## PRODUCT/PROCESS CHANGE NOTICE (PCN)

<b>PCN #:</b> A0902-03 <b>Product Affected:</b> 9 mm x 9 mm VFQFPN-64  <b>Date Effective:</b> 23-May-2009	<b>DATE:</b> 23-Feb-2009	<b>MEANS OF DISTINGUISHING CHANGED DEVICES:</b> <input type="checkbox"/> Product Mark <input type="checkbox"/> Back Mark <input checked="" type="checkbox"/> Date Code      Date code 0920 onwards <input type="checkbox"/> Other
--	--------------------------	---

### ATTACHMENT I - PCN #: A0902-03

**PCN Type:** Assembly Material Change

## OPTION 1 SAW VERSION

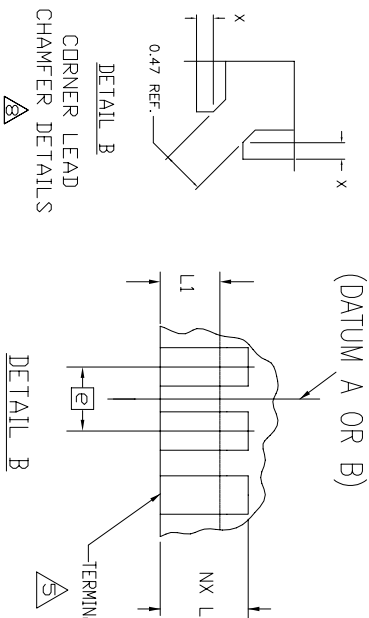
**Detail of Change:** This notification is to advise our customers that IDT plans to convert the VFQFN 64 package to a smaller exposed pad size. The new exposed pad dimensions are 6.15 mm x 6.15 mm compared to current 7.15 mm x 7.15 mm dimensions. This change is applicable to both "saw" and "punch" versions of the package at existing qualified assembly sub-cons.

Description	Current	New
Exposed Pad Dimensions	7.15 mm x 7.15 mm (+ 0.10 / - 0.15mm)	6.15 mm x 6.15 mm (+/- 0.15mm)
Package Drawing	PSC-4147, Revision 03	PSC-4147, Revision 04 (See Attachment III)

DIMENSIONS			
PACKAGE	64L 9.0x9.0 - 0.50		
REF.	MIN.	NDM.	MAX.
A	0.80	0.90	1.00
b	0.18	0.25	0.30
D	8.90	9.00	9.10
D2	6.00	6.15	6.30
E	8.90	9.00	9.10
e	6.00	6.15	6.30
L	0.30	0.40	0.50
N	ND	ND	64
ND	ND	ND	16
NE	NE	NE	16
K	0.20
